Re: RPZD-2021-003 - Dead Horse Mountain Road

THE MEADOWS AT STONEBRIDGE

PLANNED ZONING DISTRICT

C-001

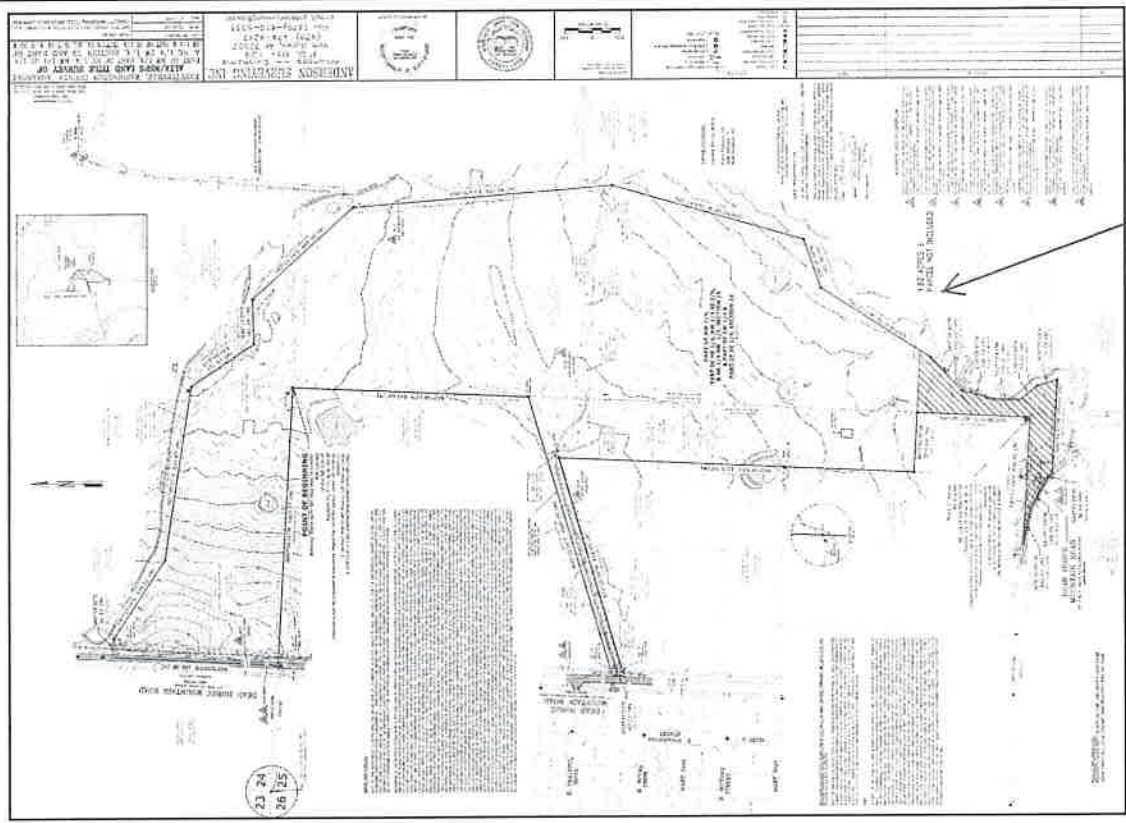
5. The RPZD contemplates using land that is owned by my clients not the Applicant (see attached plats and legal description taken from, Council packet and Applicant's March 15 PZD Booklet).

Hatched area indicates this is not part of PZD, but legal includes it.
